INDEX TO ADMINISTRATIVE RECORD

705 EUCLID AVENUE

Use Permit #ZP2022-0104

S T A F F R E P O R T FOR BOARD ACTION APRIL 27, 2023

A2.0

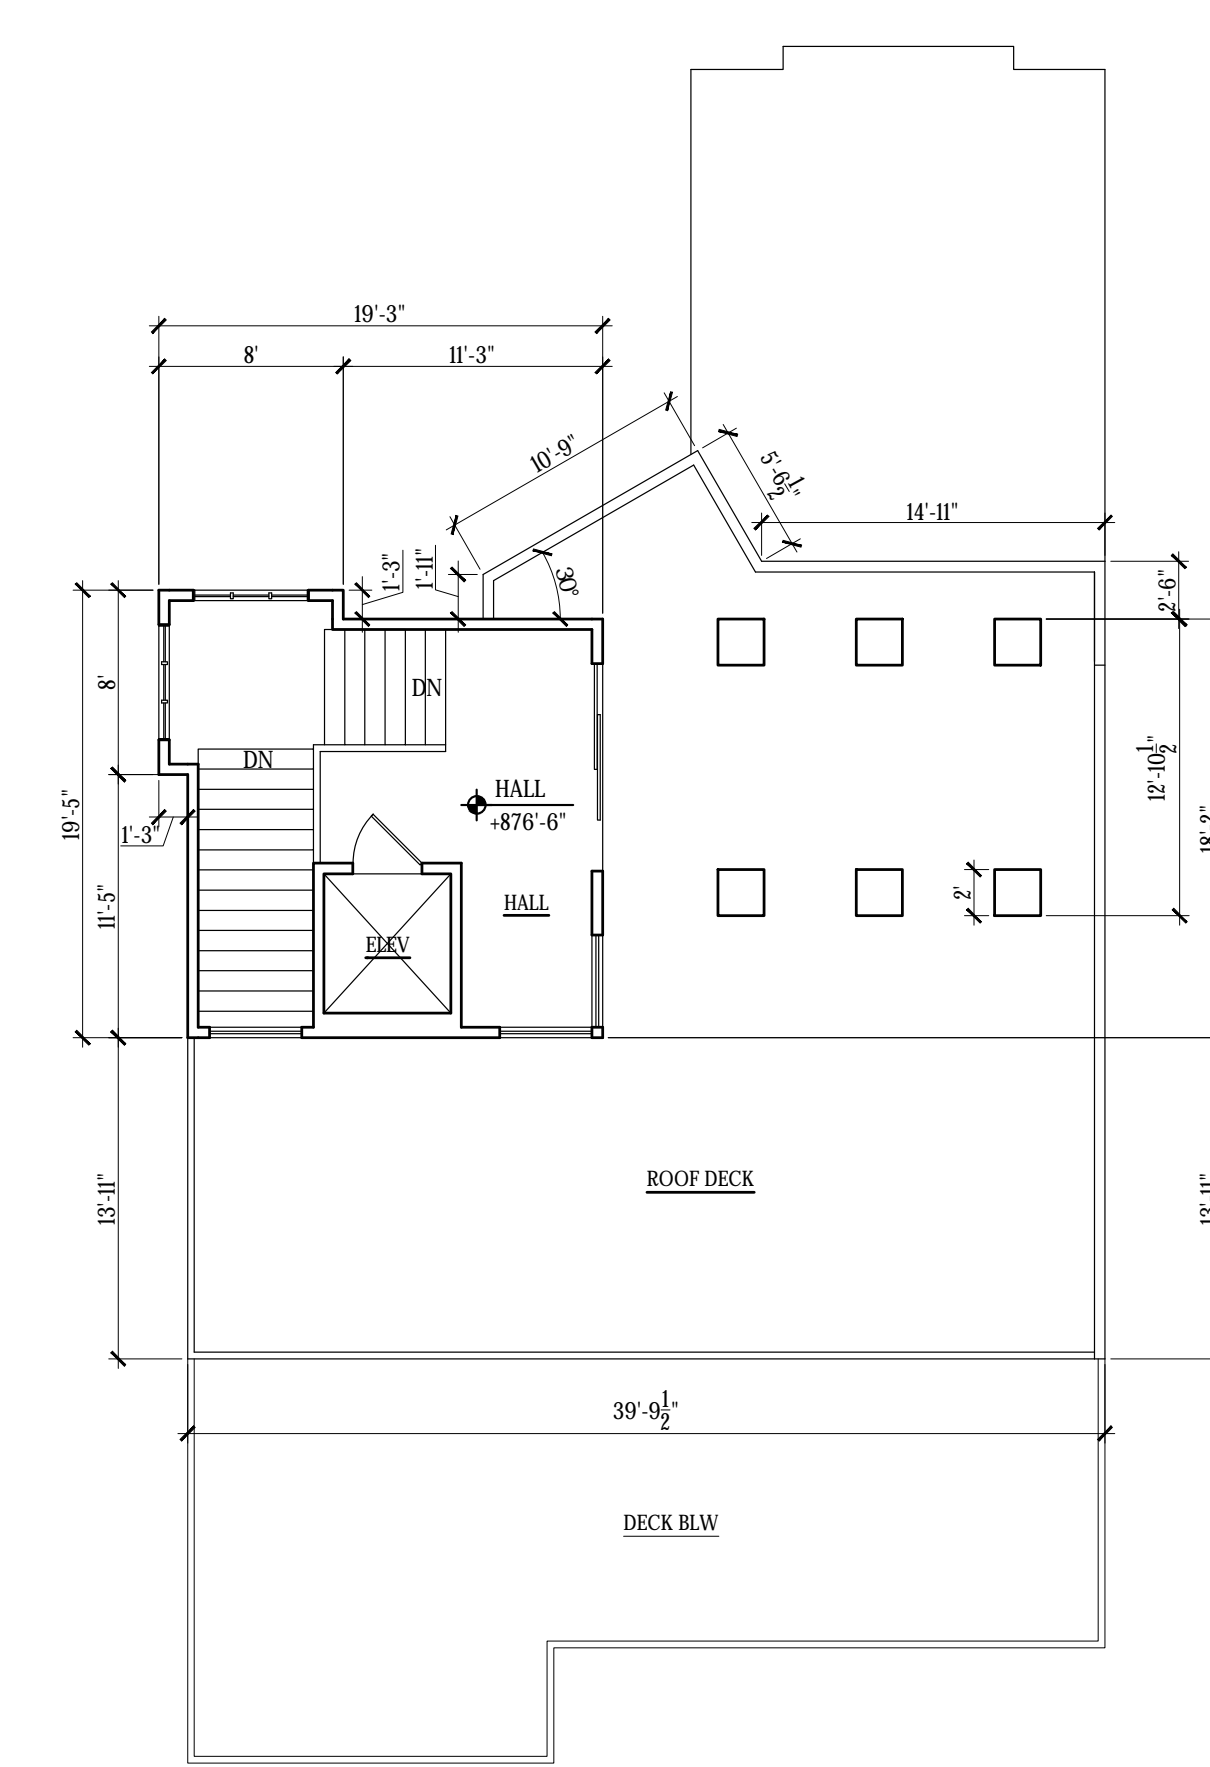
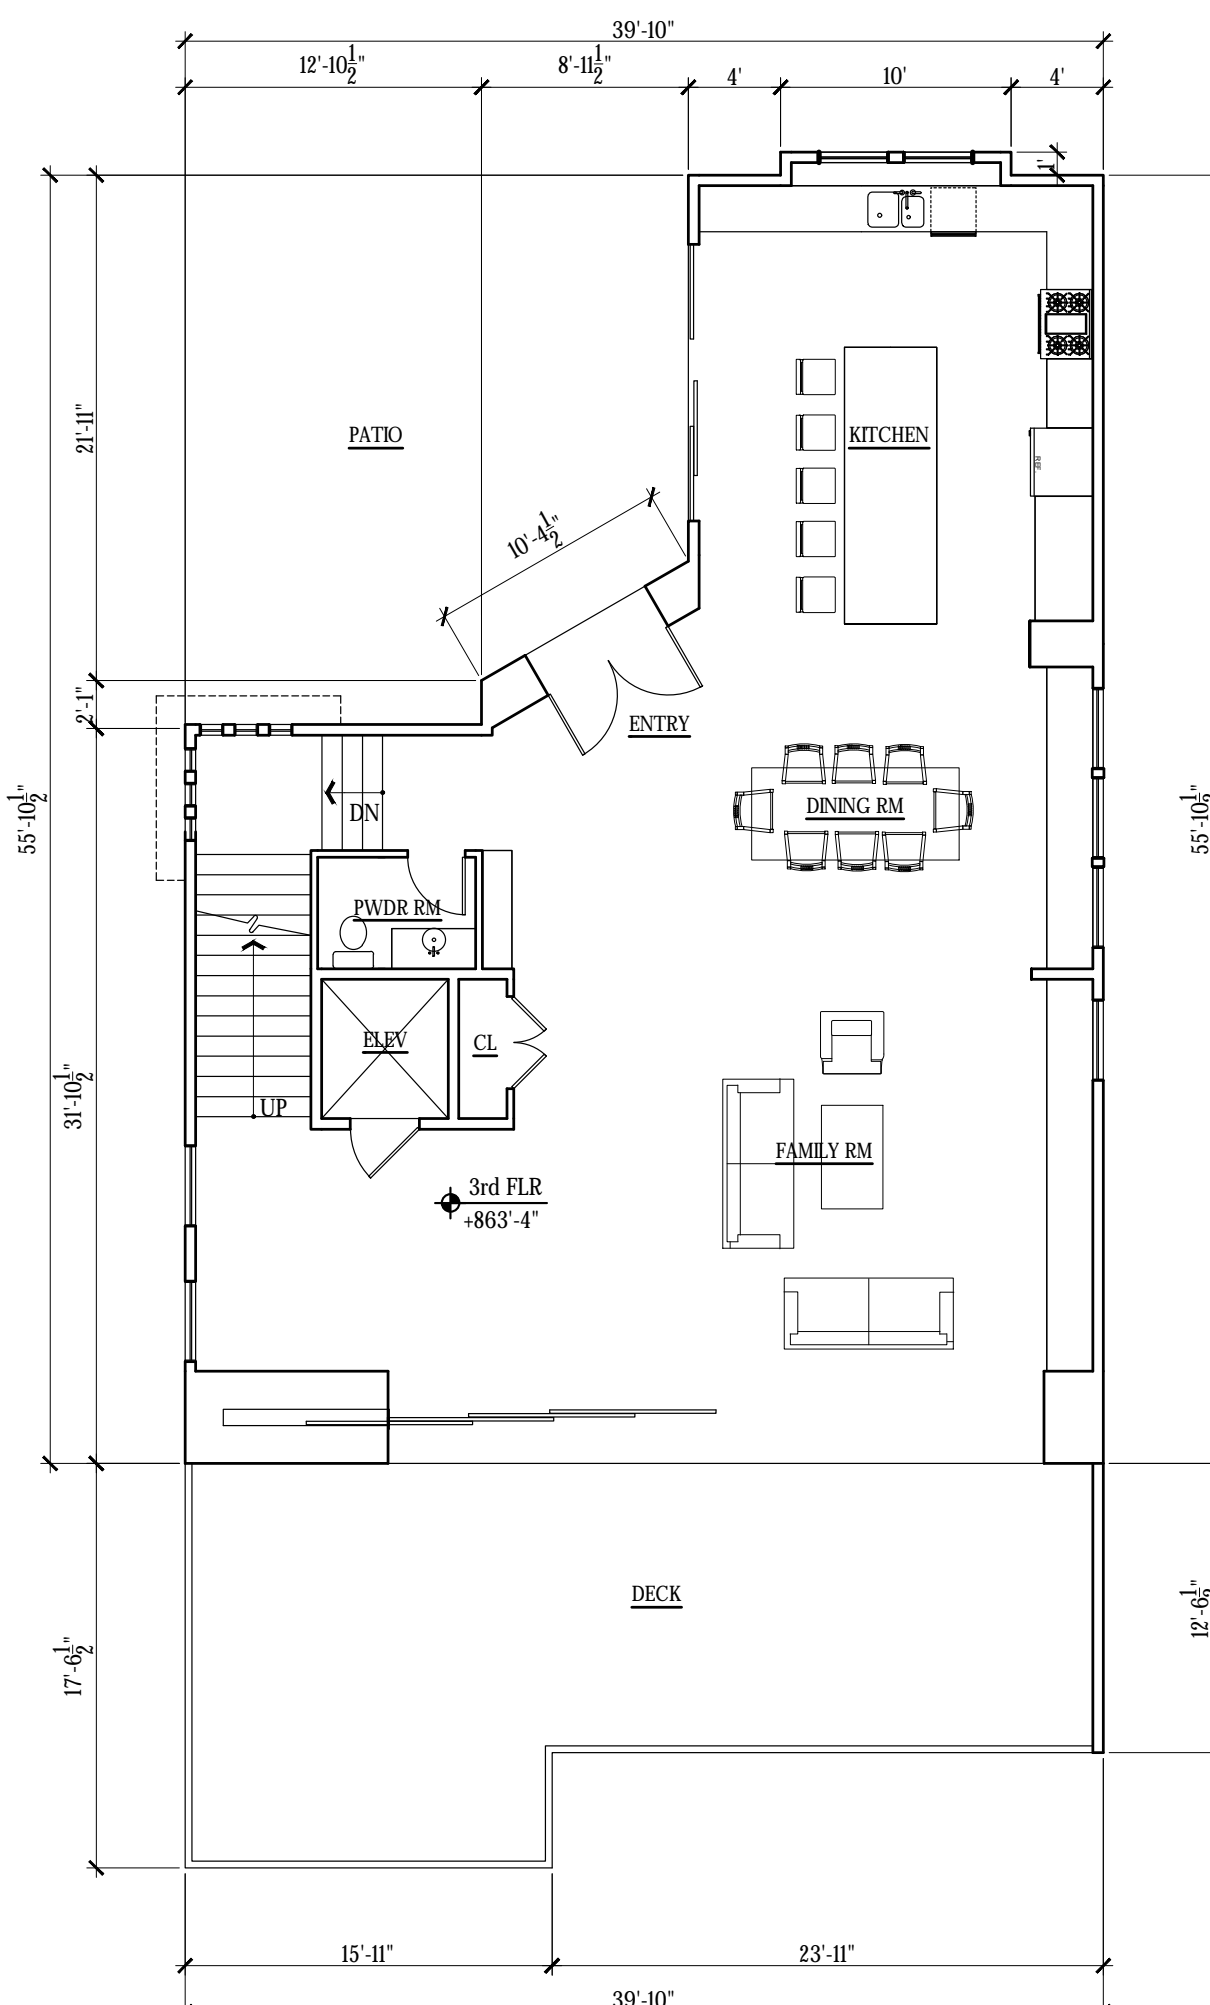
2023-04-27, pp. 1, 8), analysis of the building plans reveals that the home is actually at least five stories tall. (See **Exhibit C**, Notice of Decision at p. 24, Floor Plans sheet A2.0.)

The ZAB misinterpreted the project plans as containing three stories. The Berkeley Municipal Code defines stories at section 23.106.060 as “the portion of a building included between the upper surface of any floor and the upper surface of the floor next above. See BMC Figure 23.106-2.” Contrary to the labels applied by the project proponents and planning staff (See Staff Report for Agenda Item 6 at pages 1 and 8), the proposed residence has at least five stories, as shown in the floor plans depicted at page 24 of the pdf package distributed as the

Notice of Determination, aka Floor Plans created by CM Engineers, dated December 28, 2022, Sheet "A.2.0," and subsequent Plan sheets A.3.0 through A5.0. A 5-story structure is not permitted (even with an AUP) within the R-1H zone.

Furthermore, the topmost story (labeled "roof" or "roof deck" on Plan sheets A2.0-A4.0) is exclusively dedicated to a 1,000 square foot roof deck and access to it via an elevator and stair. There is already a roof deck on the third floor that measures 579 square feet. Per the 2022 California Building Code, using an occupant load factor of 7 square feet per person (not unreasonable for a larger social gathering), one may calculate a potential occupancy of over 140 people on the upper roof deck and over 80 on the third-floor deck. These decks are sized well beyond what is needed for any family's private use.

SP.1

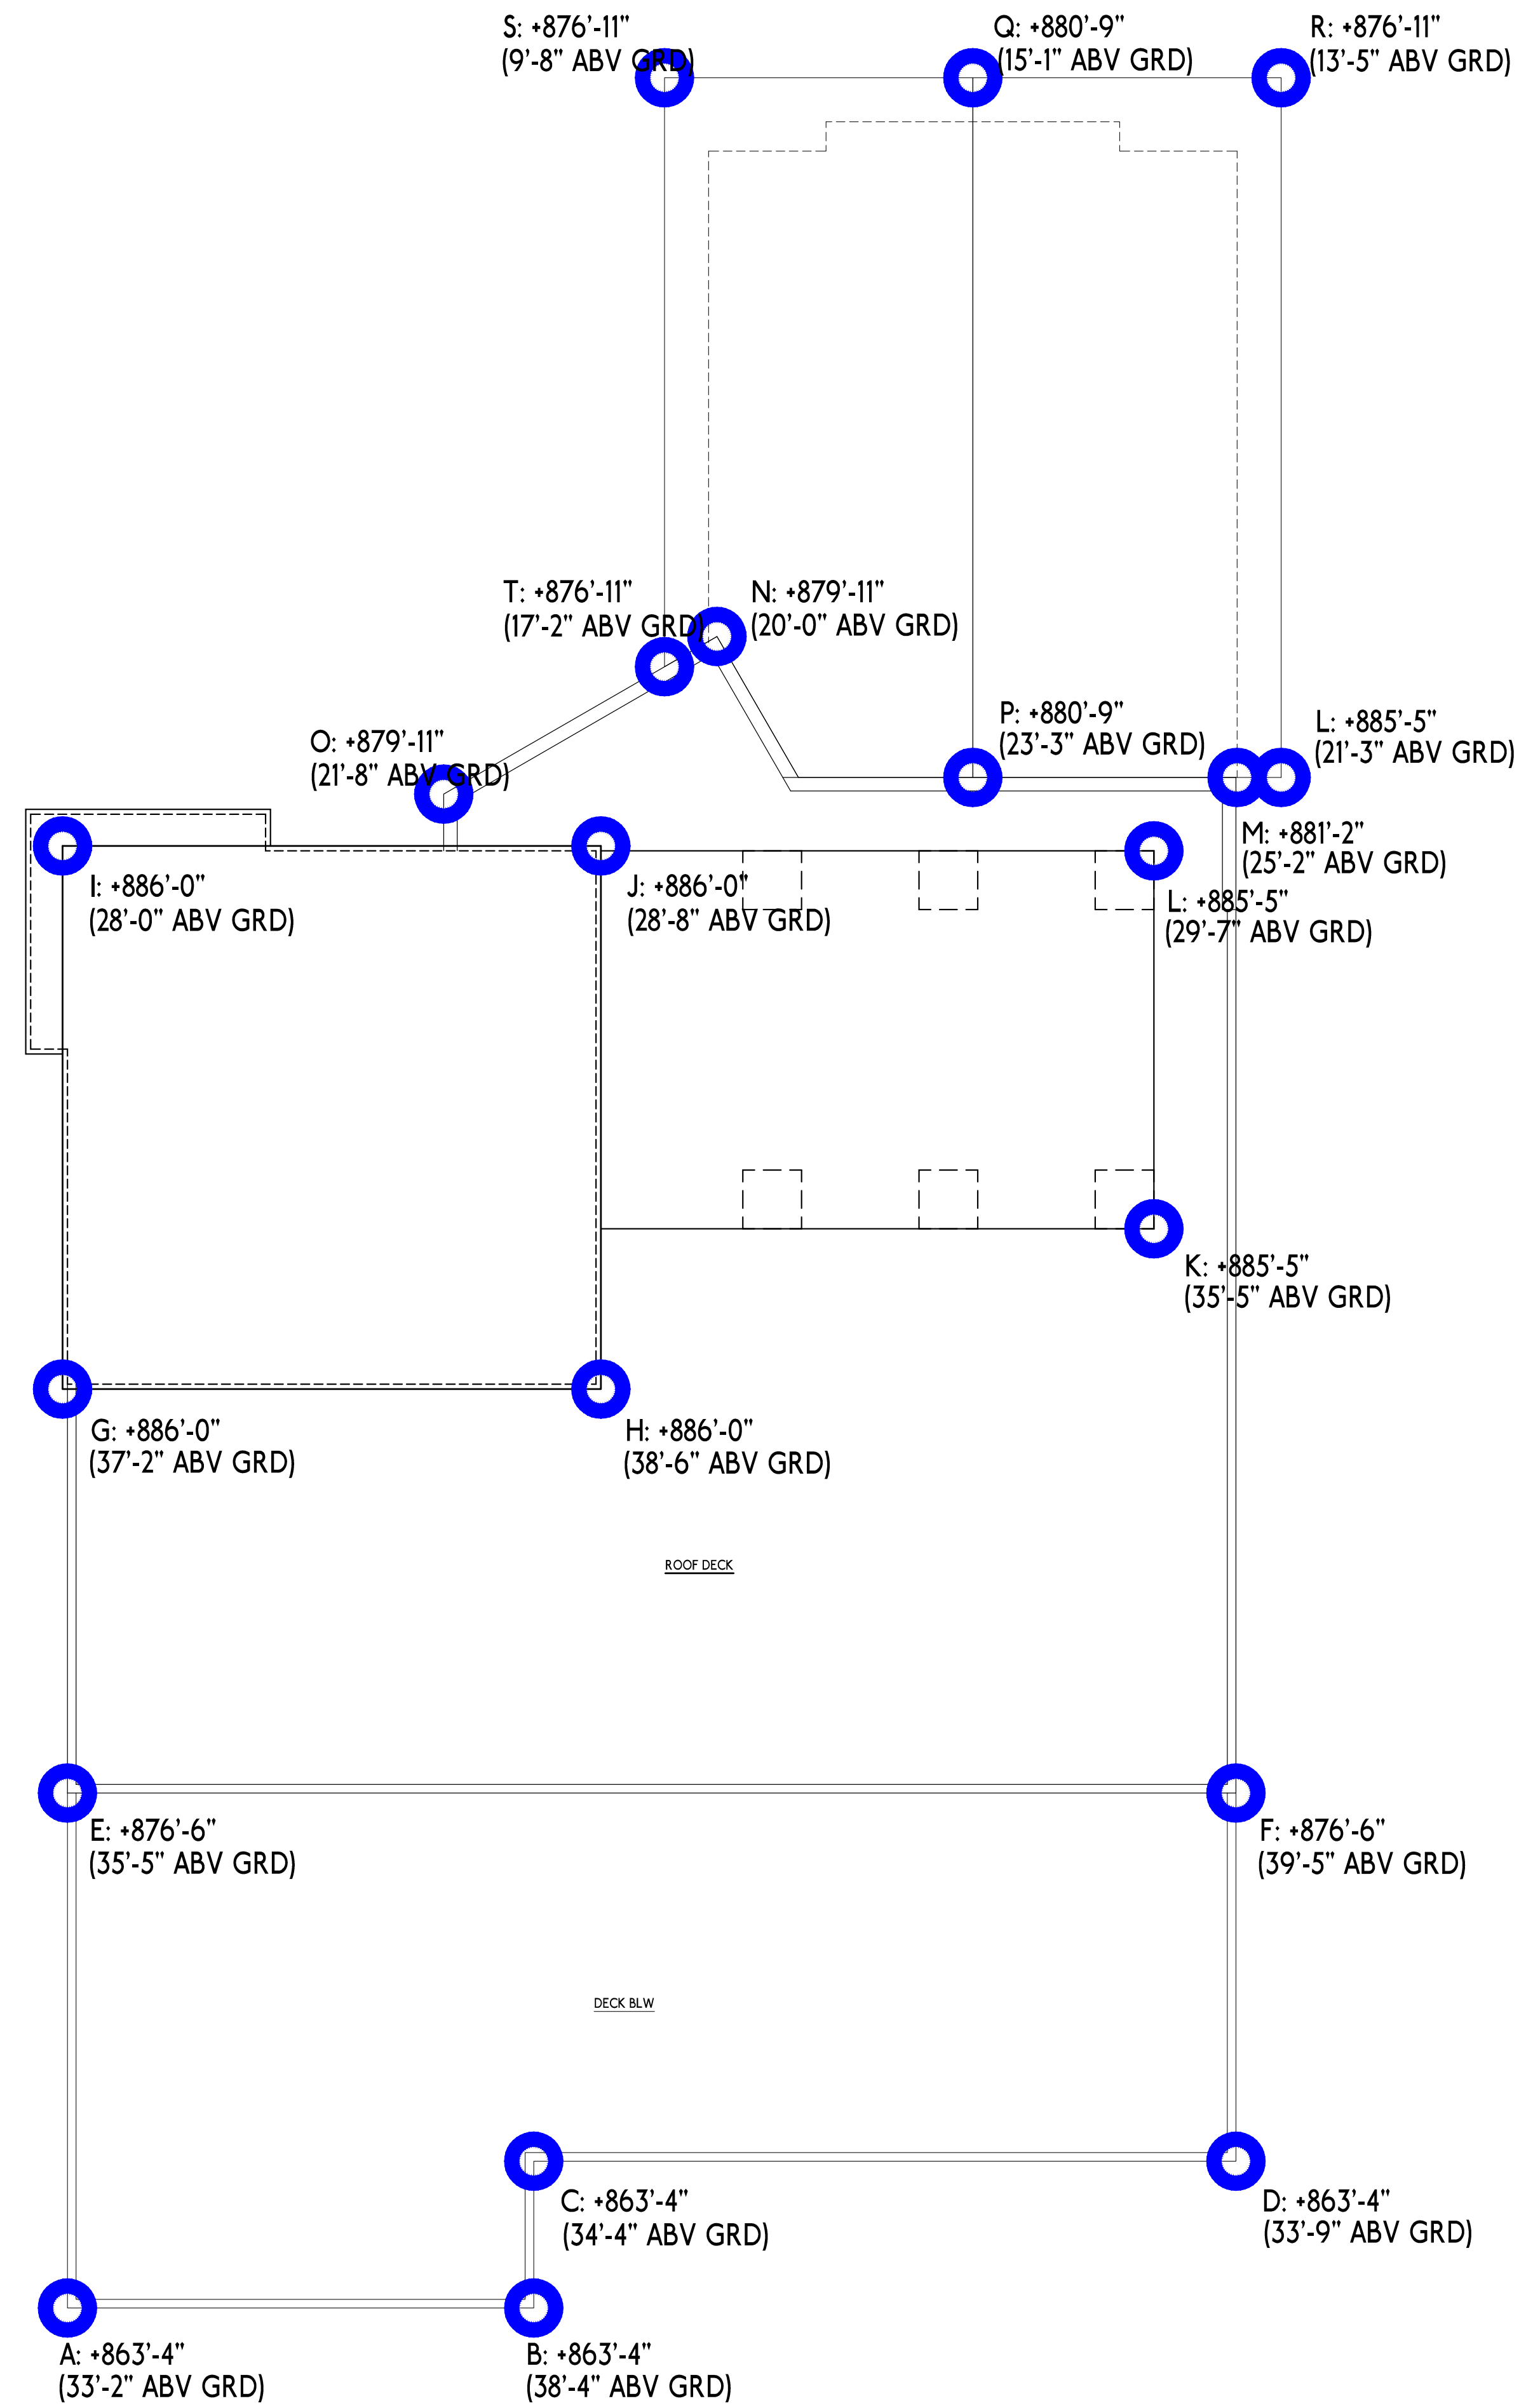
- D. Story poles erected on the site show that significant views from neighboring properties will not be unreasonably affected.
